Project: Sirius Building, 2-60 Cumberland Street, The Rocks

Project No: 301350202

RE: Air-cooled Chiller Noise Impact and Mitigation

Figure 1: Option 1: Pool Building Design

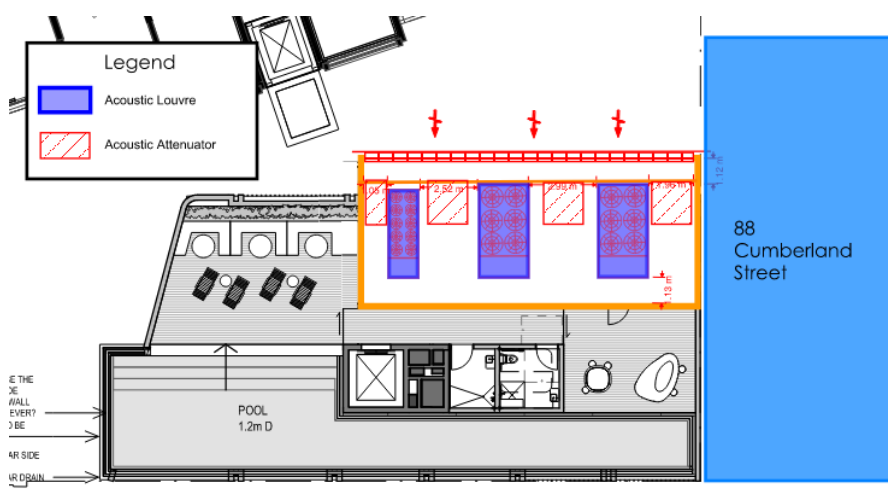
Concerns regarding the potential noise impacts to the nearby tenants and residents of surrounding sites has been raised during the submissions to State Significant Development Application (SSD-10384). Resident, Mr. John Curtis has raised a specific concern of the operation of the pool plant located to the south of the proposed development, neighbouring the site boundary of 88 Cumberland Street, The Rocks.

The purpose of this technical memorandum is to outline any specific mitigations to demonstrate that the requirements and criteria set by the NSW EPA Noise Policy for Industry (NPI) have been met and to address Point 4 of the listed submission response.

For this design option, acoustic attenuators are proposed to attenuate noise emissions from air-cooled chillers at the intake interface of the plantroom, and acoustic louvres are proposed to attenuate discharge noise emissions from the air-cooled chillers. See Figure 1 for further information.
